ADDENDUM NO. 1

PROJECT: FIRST STREET OVERLAY PROJECT

BID CALL NO. 722-23; PROJECT NO. 23-06

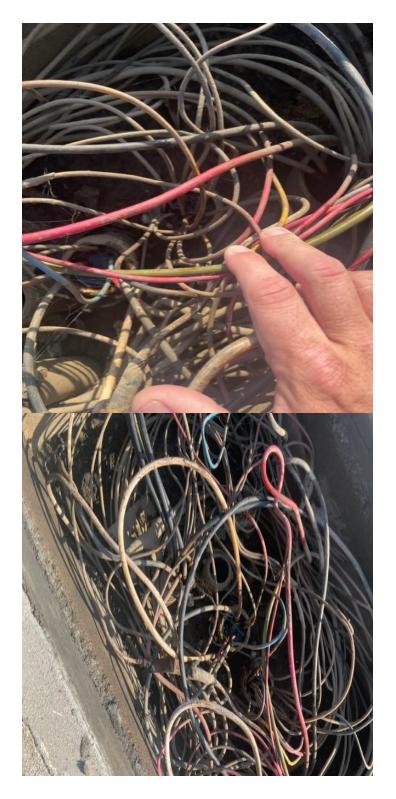
5. Bid RFI No. 5: The Bid Item and plan note indicates Lead in Cables to be replaced. Is it the intention of the City to replace the Lead in Cables back to the signal controller? If this is so, how many cables are there and can be pulled thru the existing conduits without removing existing cables?

Response: It is anticipated that replacement of cabling complete to the controller is required. The existing detector loops affected by the project are already damaged and the signal is currently operating in recall mode as a result of this existing damage. As such, there is no requirement to preserve the existing cabling in place during replacement. A portion of the cabling run is in conduit but not the full length. Please refer to the site photographs included herewith to supplement the information provided on the as-built
